**Re: Item 2 on PTC October 9th Agenda - Stream Corridor Protection and Review**

**18.40.140 Stream Corridor Protection and Review**

**10/9/2024 PTC Item 2: Draft Ordinance, Stream Corridor Protection**

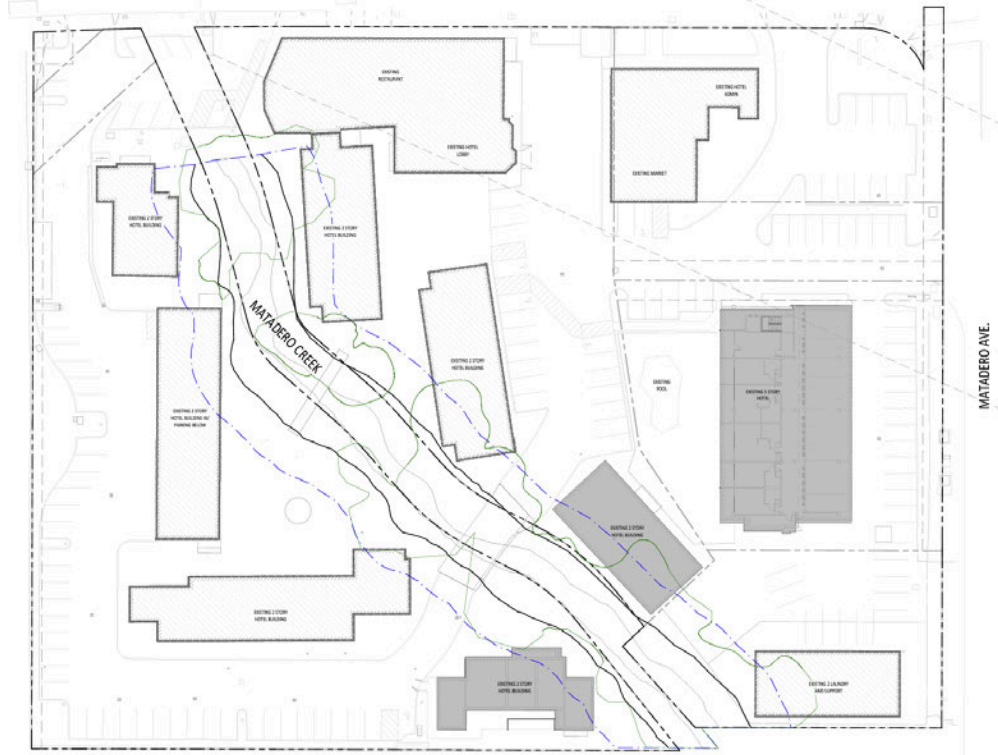
The proposed Streamside Setback may increase non-buildable zones another 20' (from 20' to 40') which would have a negative impact on the property's potential, particularly on an infill project, and more than likely render a redevelopment infeasible. There are not likely many instances in Palo Alto where a property possesses a natural creek, multi-family and commercial zoning with existing uses, but we would urge the Planning & Transportation Commission to consider this and other potential properties that could jeopardize significant housing opportunities in Palo Alto.

Included in this memo is a site plan of the most recently proposed project that illustrates 20' setbacks from top of bank, as consistent since 2022 applications. There are 2 existing buildings that would remain and are within the 20' top of bank setback, while 5 other buildings that are also within the 20'

setback would be removed and replaced by structures outside the 20' setback. The Planning Department has the complete application on hand for greater detail.
